Delegated Report

Variation of Condition Application

Planning Application No: 20250315

Description: Application for variation of condition 2 attached to planning permission reference number 20240527 for construction of DNO kiosks, Low Voltage Cabinets and associated Cabling; to allow the cable design to be amended.

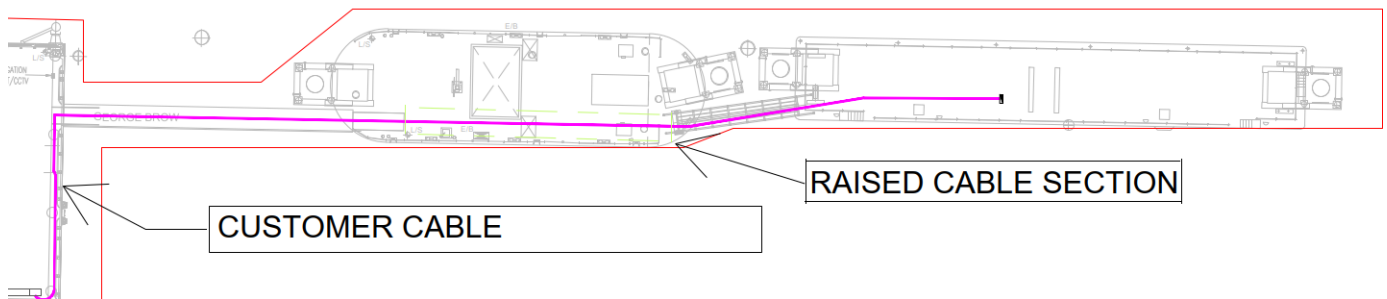
This application seeks to amend a small portion of the cabling, that is the part on the George pontoon. In the approval this cabling was to run under the pontoon but it is now proposed to go over it instead. The reason for this is said to be to mitigate safety risks as it is said that to have the cable on the floor could pose a safety risk. The cabling would be at a height of 3m on support poles and it is said it would be the same as the raised cabling permitted on the Svitzer pontoon.

The proposed change of the cabling on the George pontoon from being on the ground to being at a height of 3m on supports posts is considered acceptable in design terms. The proposed raised cabling would match the adjacent raised cabling either side which has already been approved under application ref. 20240527. It would therefore not appear out of keeping and would not impact on the character of Denton Wharf or the surrounding area.

A close up of the plan form of the George pontoon and surrounding sections is shown below:

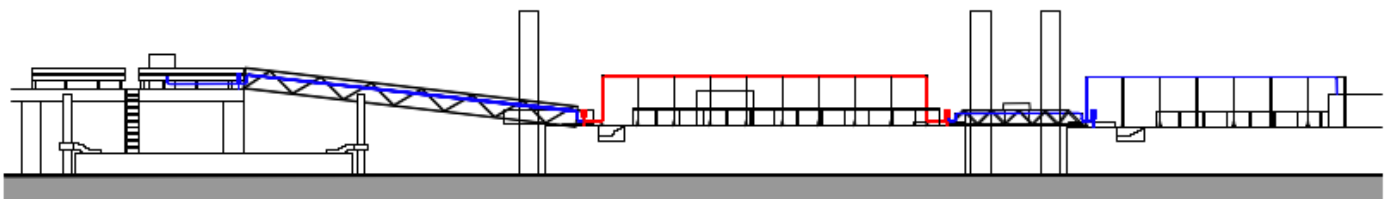
The proposed raised section on the George Pontoon is shown in red below alongside the already permitted raised cabling sections in blue.
